**Addendum (Revision 1) to Remedial Action Options Report (RAOR)  
and Pre-Design Sampling Work Plan - Connell Aluminum Properties, LLC  
Former Koppers Tar Plant and Wabash Alloys Site  
9100 S. 5<sup>th</sup> Avenue, Oak Creek, WI 53154  
BRRTS# 02-41-553761, FID#241379050  
Connell VPLE BRRTS #:06-41-560068**

January 11, 2021

**City of Oak Creek Utility Corridor Lot 1  
9170 South 5<sup>th</sup> Avenue, Oak Creek, WI 53154  
BRRTS#: 02-41-561425, FID #:341074470  
VPLE BRRTS#: 06-41-561426**

This Addendum (R1) letter addresses the WDNR's comment letter dated October 25, 2017 and the additional June 10, 2020 comment letter provided to Connell upon WDNR's review of the March 13, 2020 Addendum regarding *Review of Site Investigation and Remedial Action Options Reports, Former Koppers Tar Plant and Wabash Alloys Facility*. On July 7, 2020, Connell participated in a conference call with the WDNR in which we discussed our proposal for revising the Addendum to address the WDNR's June 2020 comments. We discussed increasing the cap extents in several areas to closely match the extents planned by Beazer for capping the creosote-impacted (PAHs) soil, for which WDNR did not have an objec

**FIGURE 1**  
FIGURE 9 (REV. RAOR REPORT)

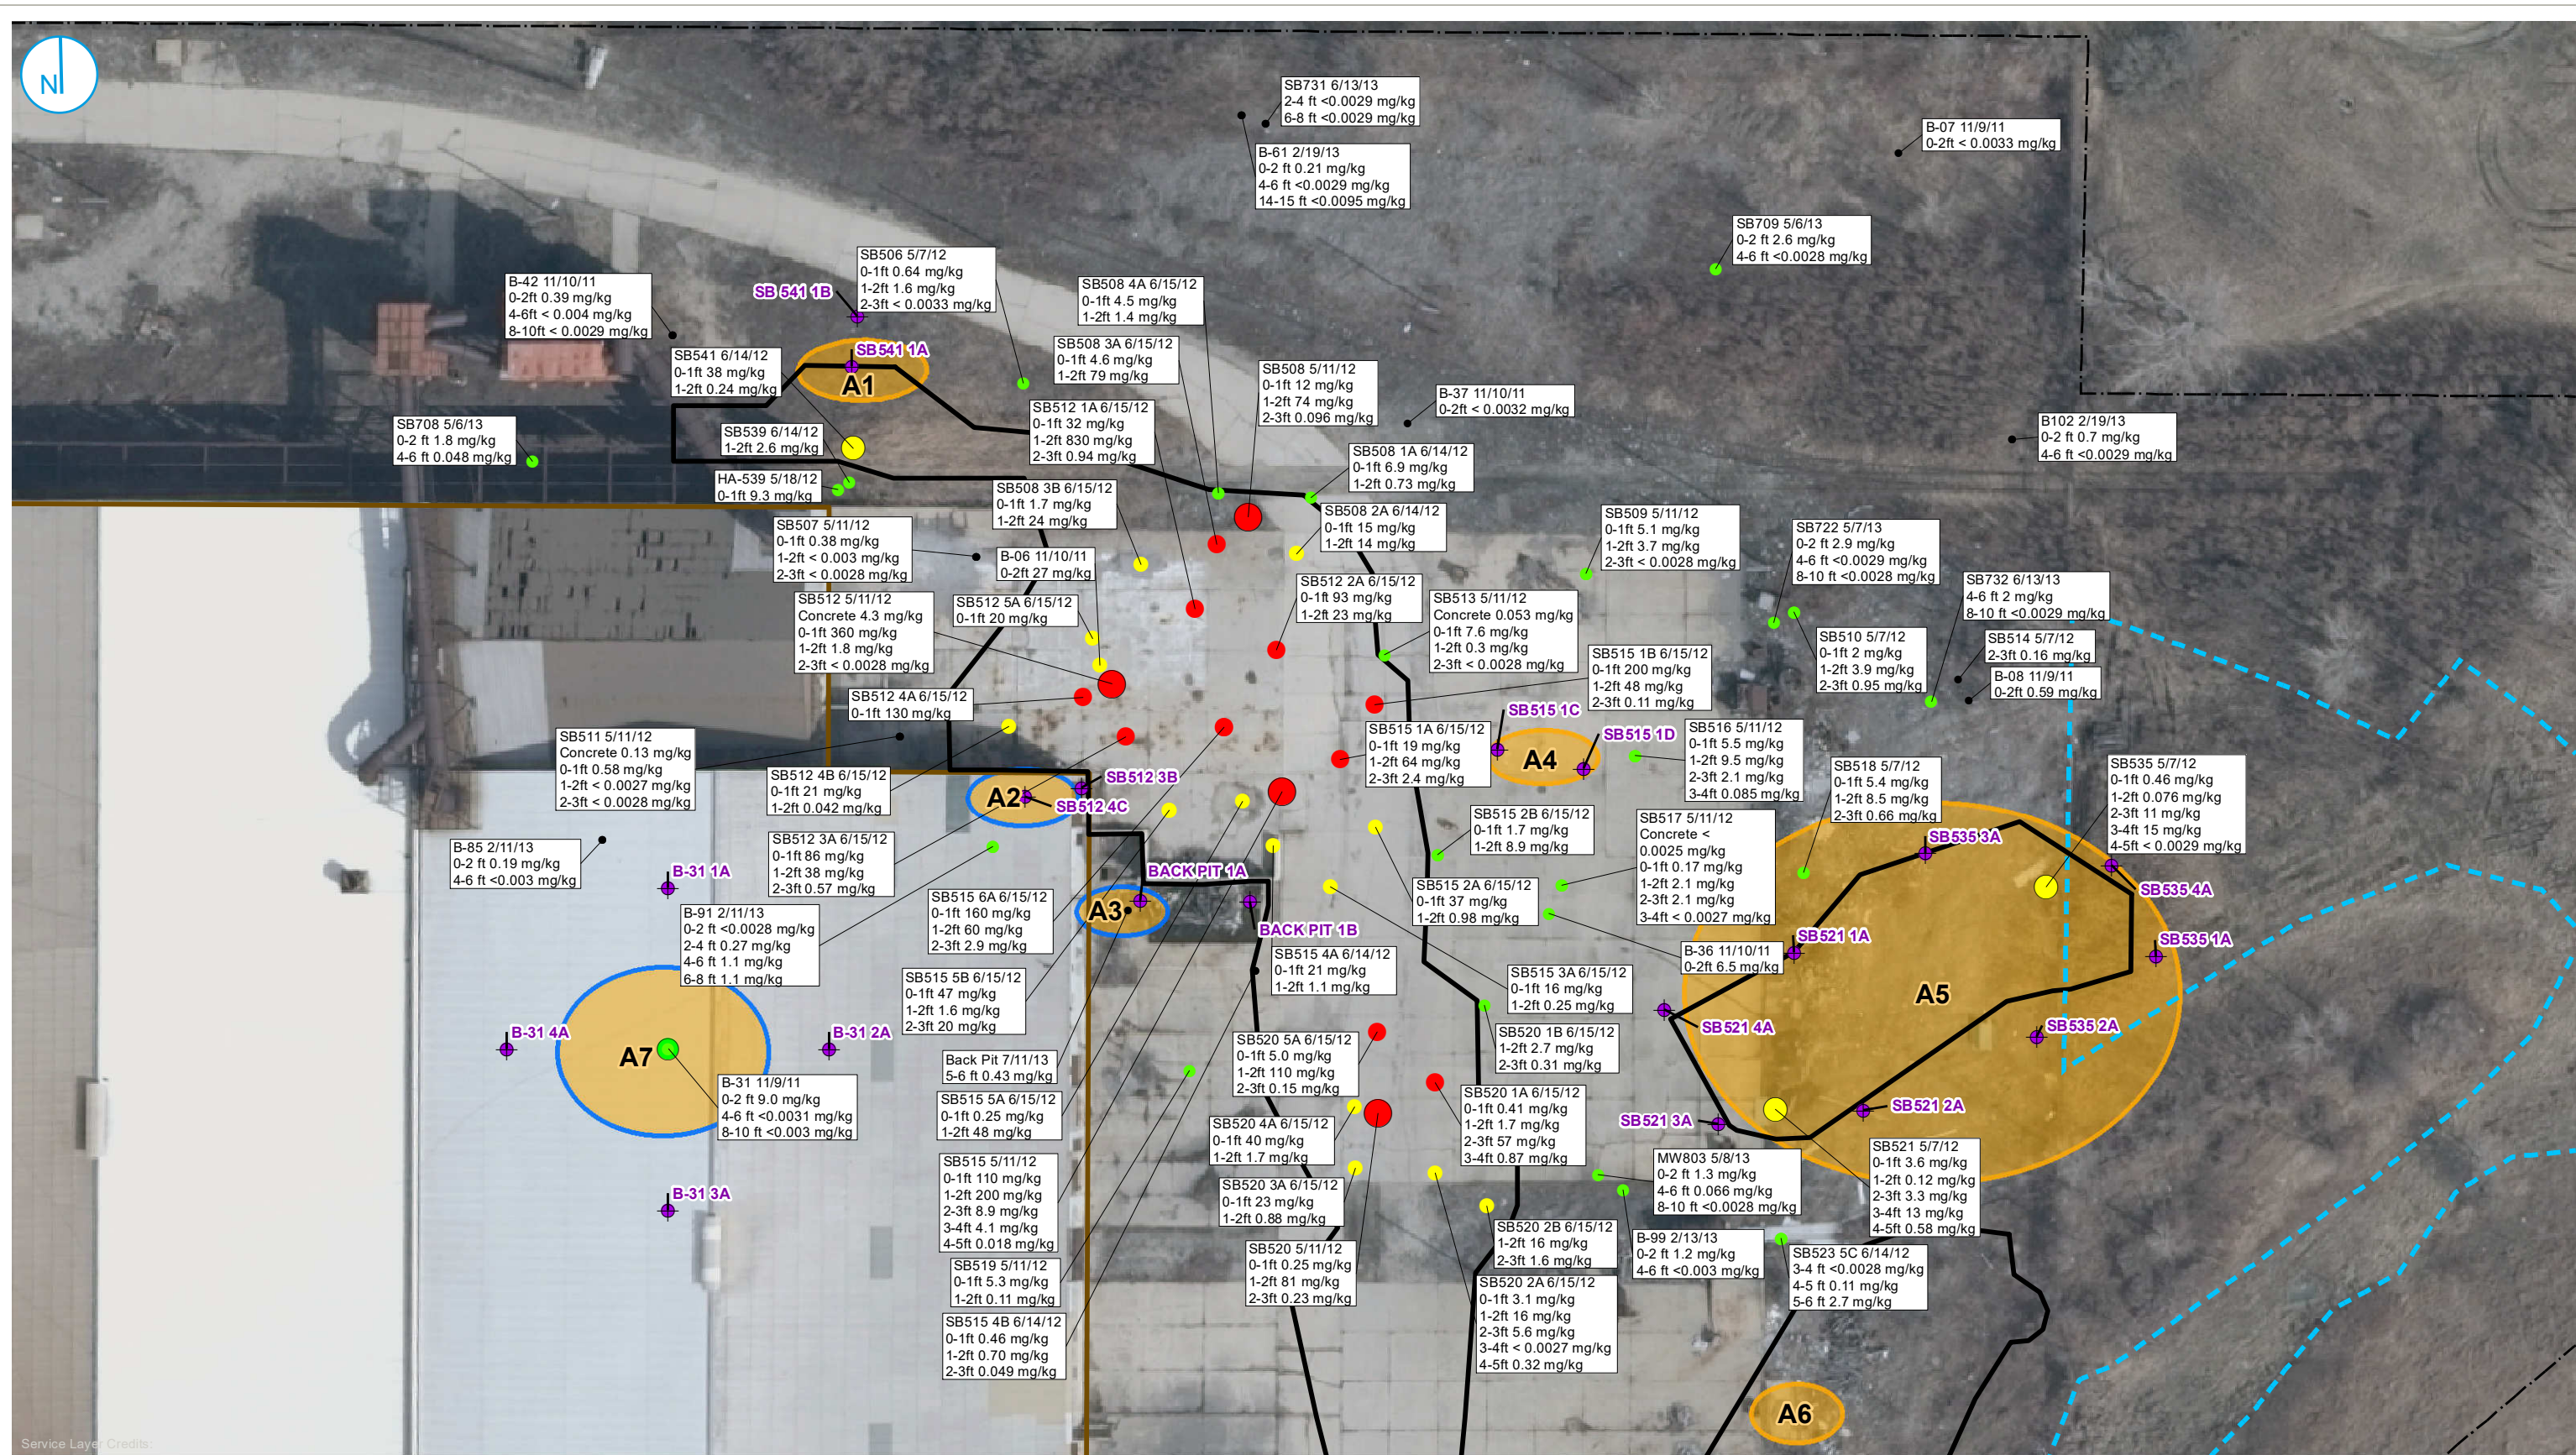
- Figure 1 – Revised RAOR Figure 9 – PCB Soil Excavation and Disposal (Alternative S-4) for purposes of showing all 6 planned excavation areas (Western Areas 1 through 5 and Eastern Area 6) and showing all 10 locations by comment number (A1 through A10) that WDNR identified as additional PCB sampling locations. Note 1 was revised and Notes 2 and 3 were added to include notes about the planned excavation confirmation sampling and sampling of the below grade concrete foundations where PCBs are identified in soil.

**FIGURE 2**  
**FIGURE C40 (REV. SI REPORT)**

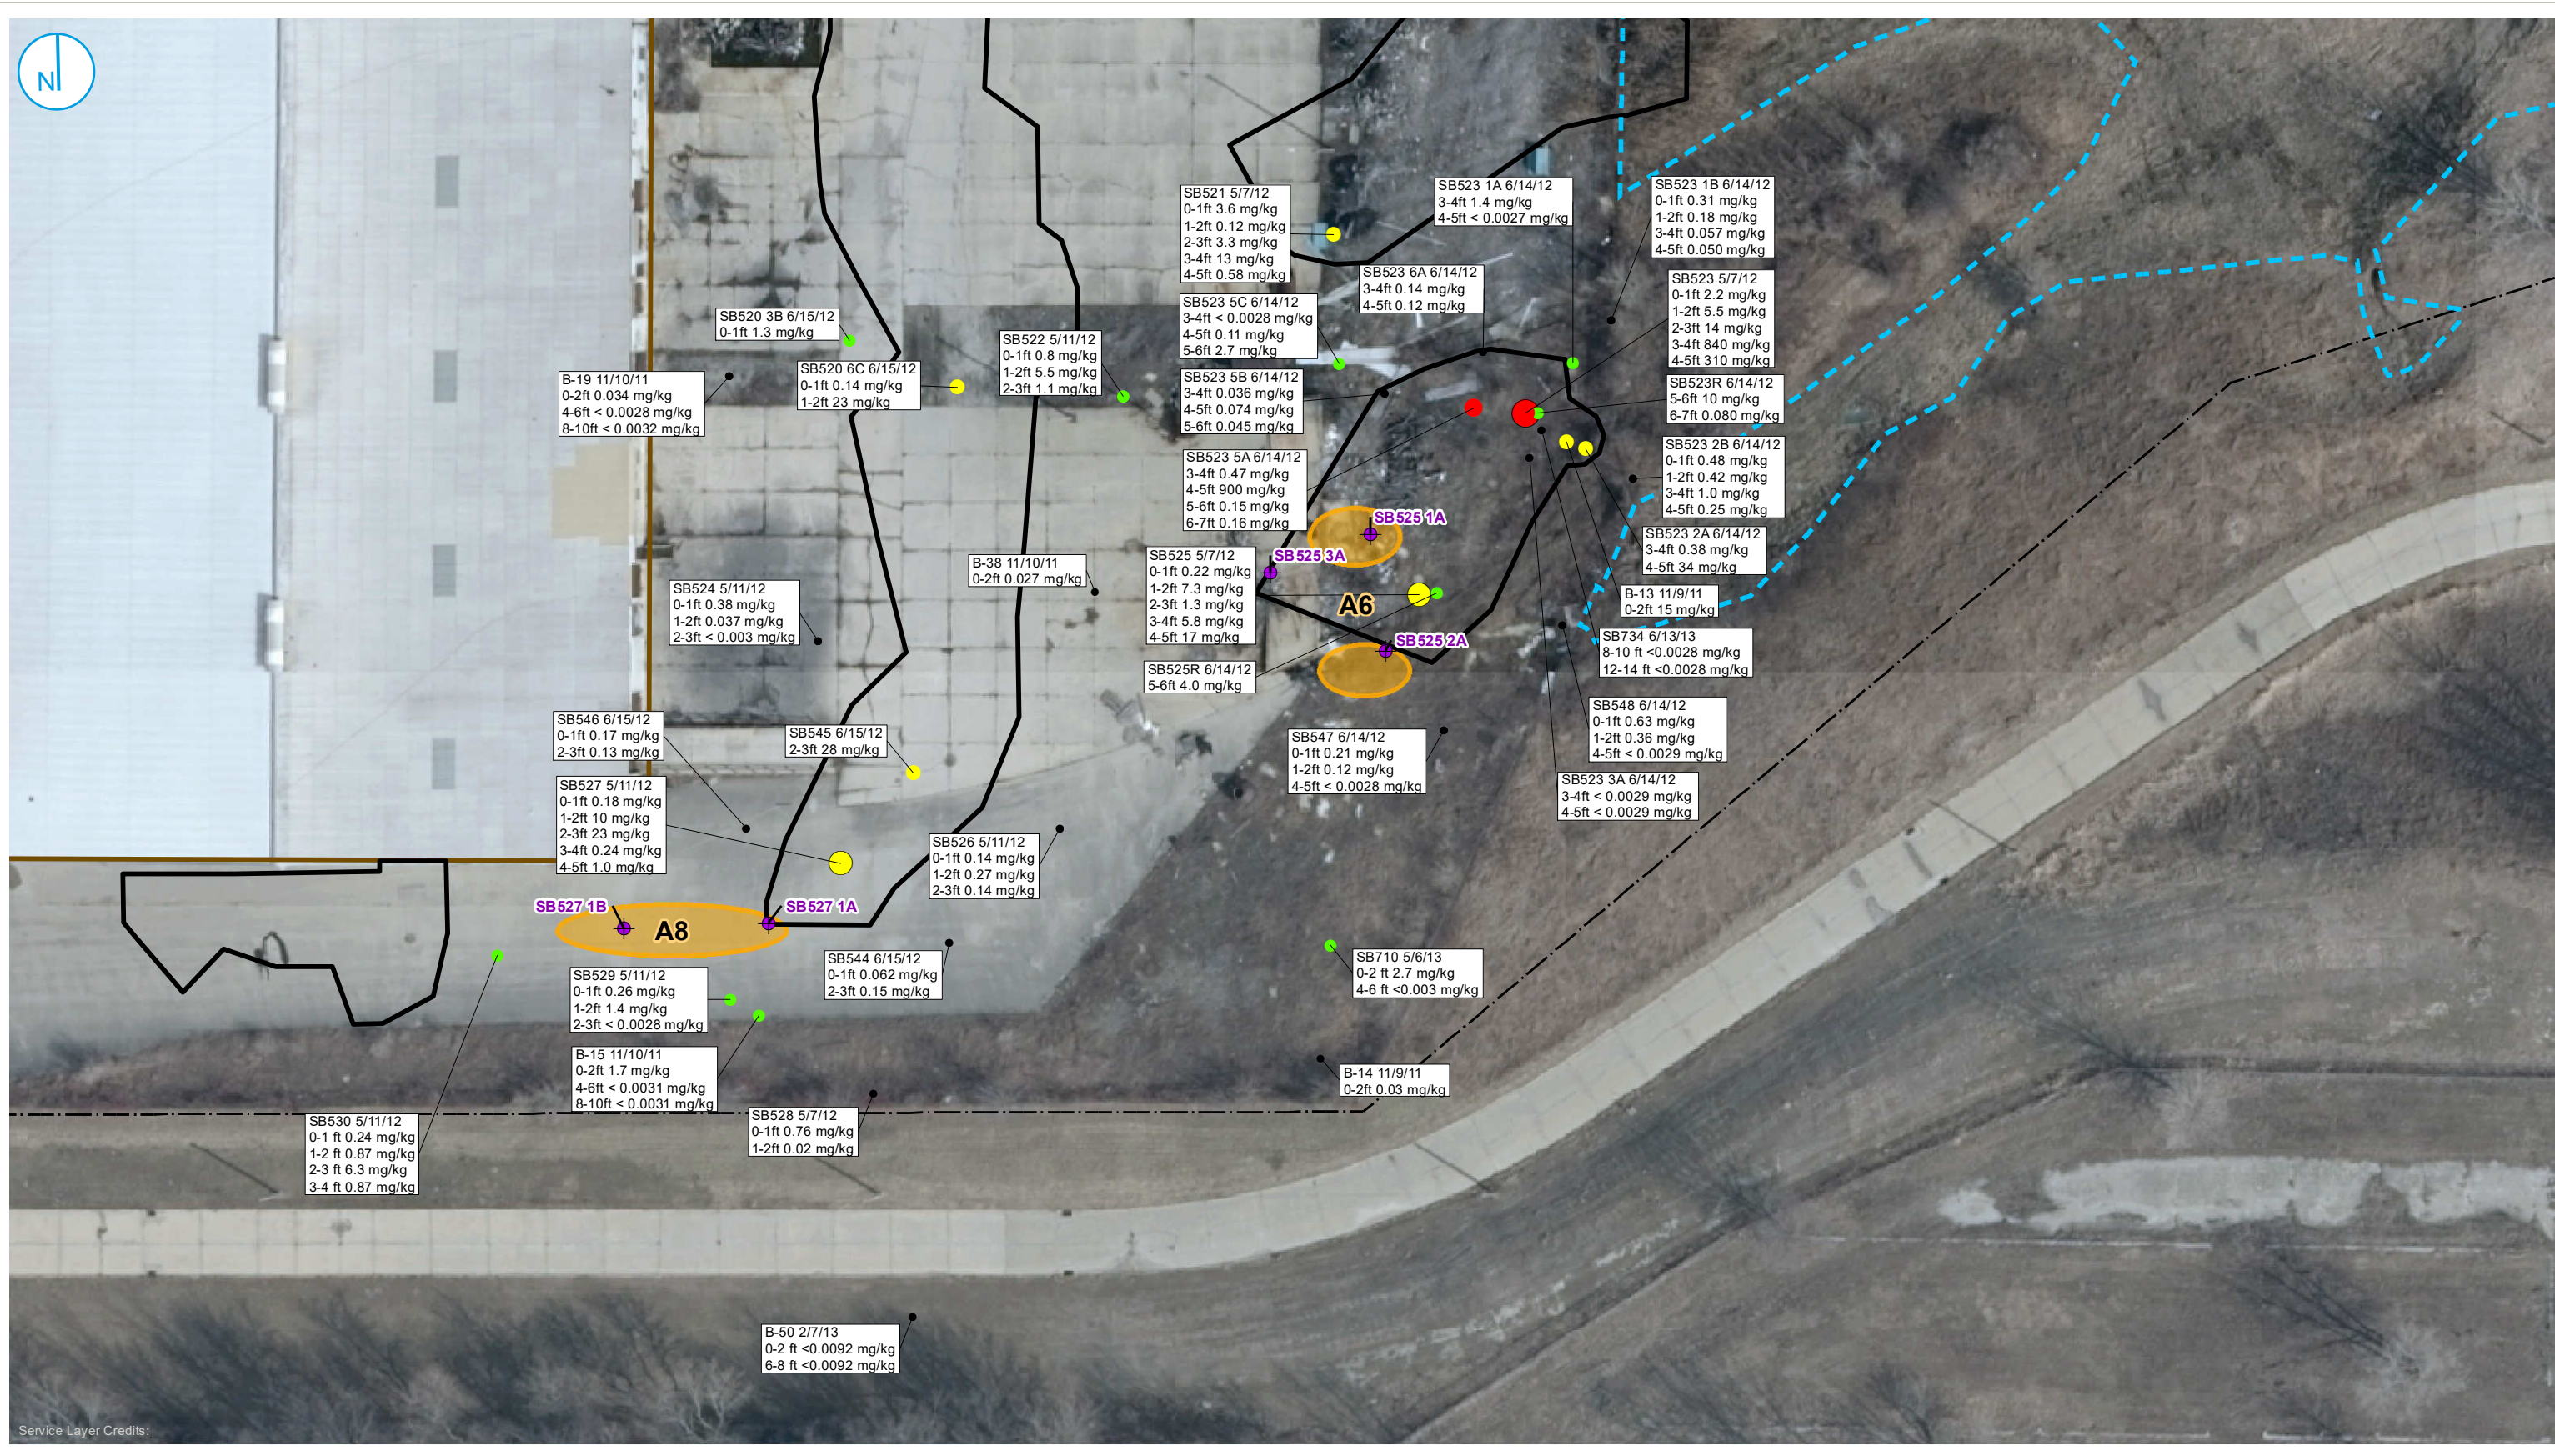
- Figure 2 – Revised Figure C40 SI Report - PCB Soil Data – North Yard TSCA Area for purposes of showing more specifically the additional PCB sampling locations related to comments A1 through A5, and A7.
